Addendum 21: Regulation No. 22

Revision 3 - Amendment 1

UNIFORM PROVISIONS CONCERNING THE APPROVAL OF PROTECTIVE HELMETS AND THEIR VISORS FOR DRIVERS AND PASSENGERS OF MOTOR CYCLES AND MOPEDS

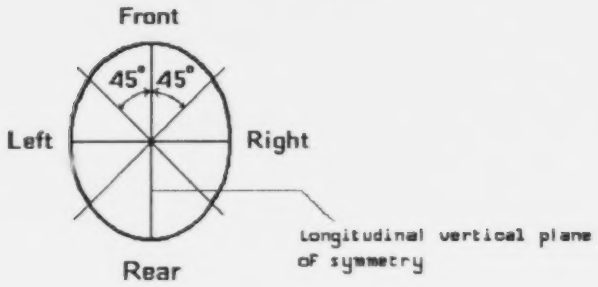
The total surface area and shape of the reflective part used shall be such that in each direction, corresponding to one of the areas defined in the figure below, visibility is ensured by a surface area of at least 18 cm^2 of simple shape and measured by application on a plane.

In each surface area of minimum 18 cm^2 it shall be possible to mark:
either a circle of 40 mm diameter;
or, a rectangle at least 12.5 cm^2 in surface area and at least 20 mm in width.

Each of these surfaces shall be situated as near as possible to the point of contact with the shell of a vertical plane parallel to the longitudinal vertical plane of symmetry, to the right and to the left, and as near as possible to the point of contact with the shell of a vertical plane perpendicular to the longitudinal plane of symmetry, to the front and to the rear.

Figure 3: Identification of points of impact

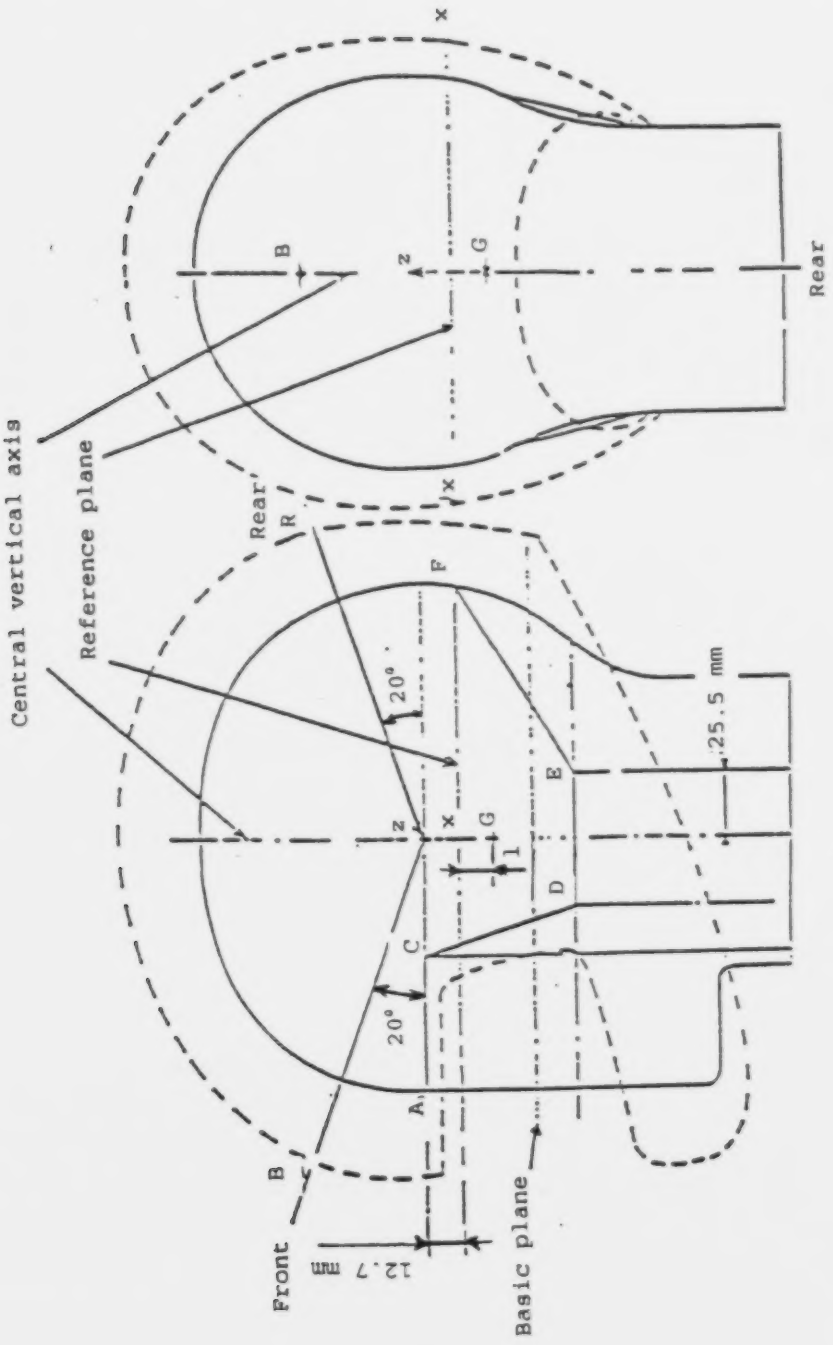
Annex 4, Figure 3, amend as follows, to show point R (as defined in new paragraph 7.3.4.2.):

7.3.4.2. Four points of impact are defined for each helmet:

B, in the frontal area, situated in the vertical longitudinal plane of symmetry of the helmet and at an angle of 20° measured from Z above the AA' plane.

X, in either the left or right lateral area, situated in the central transverse vertical plane and 12.7 mm below the AA' plane.

R, in the rear area, situated in the vertical longitudinal plane of symmetry of the helmet and at an angle of 20° measured from Z above the AA' plane.

P, in the crown area, situated above the AA' plane and above the transverse plane passing through B and Z, and not within 50 mm of the other points.

Figure 4: Apparatus for testing slippage of the chin strap

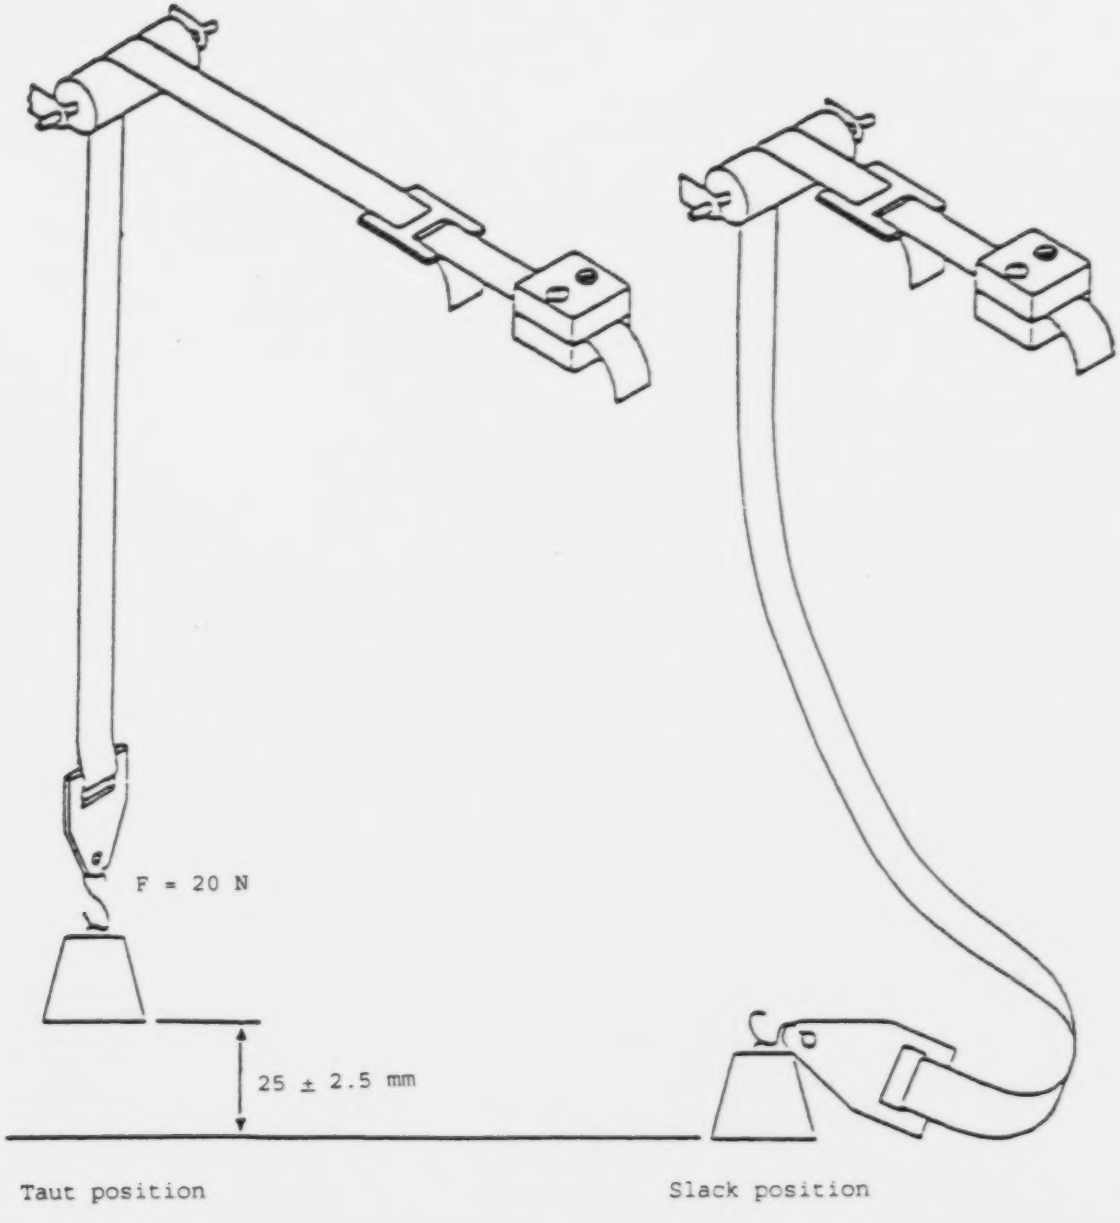
"7.9. Micro-slip test of the chin strap (see annex 8, Figure 4)

Annex 8, insert new Figures 4 and 5, to read as follows:

7.9.1. The test rig consists of a flat horizontal robust base, a weight for applying a load, a freely rotatable horizontal roller of diameter not less than 20 mm, and in the same horizontal plane as the top of the roller a clamp capable of reciprocating horizontal motion at right angles to the axis of the roller with a total amplitude of 50 ± 5 mm at a frequency between 0.5 Hz and 2 Hz.

7.9.2. Take a sample of the strap at least 300 mm long, including the tensioning and adjusting device and any additional strap fastening. Fix the upper end of the strap to the reciprocating clamp level with the top of the roller and drape the strap over the roller. Attach a weight to the lower end of the strap so that when the weight is lifted by the strap it imposes a tensile force of 20 ± 1 N. Adjust the apparatus so that when the reciprocating clamp is at the centre of its motion the weight is just resting on the base with the strap barely in tension and the strap buckle is between the clamp and roller and will not touch the roller during reciprocation.

7.9.3. Operate the reciprocating clamp for 20 cycles. Note the position of the components on the strap. Operate the reciprocating clamp for 500 cycles then record the distance through which the components have slipped along the strap.

7.9.4. The total slippage through the grip shall not exceed 10 mm.

Figure 5: Apparatus for testing abrasion of the chin strap

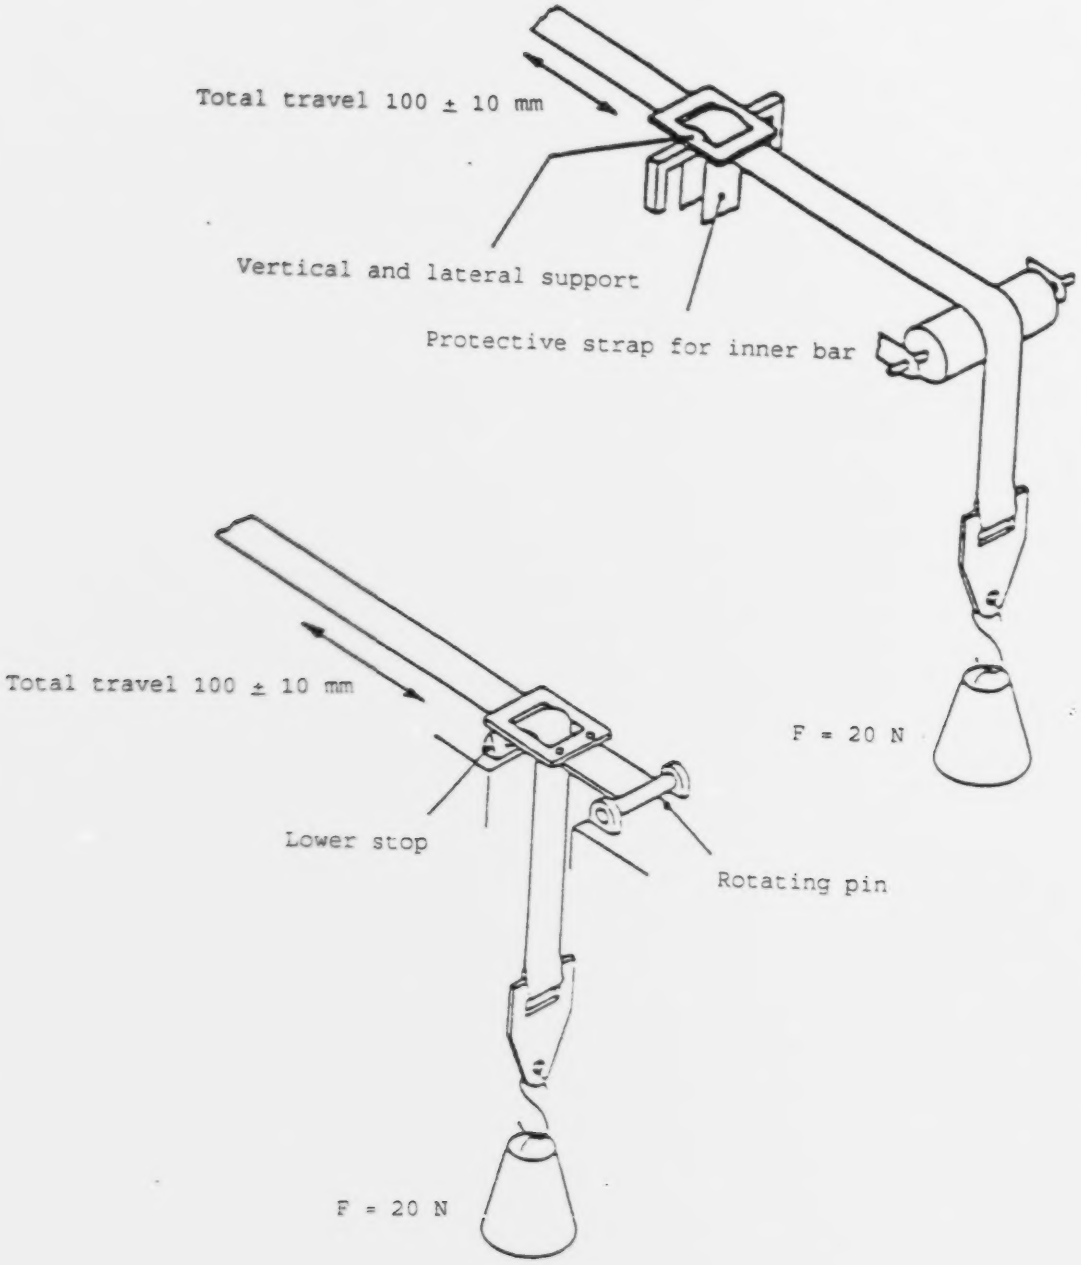
7.10. Test for resistance to abrasion of the chin strap (see annex 8, Figure 5)

7.10.1. The test rig is similar to that described in paragraph 7.9.1. except that the amplitude of motion is 100 ± 10 mm and the strap passes over a representative surface of the associated adjuster or other strap fitting through an appropriate angle.

7.10.2. Select an arrangement of the apparatus appropriate for the particular design of both the strap and the fitting likely to cause abrasion. Grip one end of the strap in the oscillating clamp, arrange the strap to be threaded through the fitting as designed and hang a weight on the end to tension the strap with a force of 20 ± 1 N. Mount or otherwise steady the fitting in such a

position that movement of the oscillating clamp slides the strap through the fitting, in a manner simulating slippage of the fitting on the strap when the helmet is on the head.

7.10.3. Oscillate the clamp for a total of 5000 cycles at a frequency between 0.5 and 2 Hz.
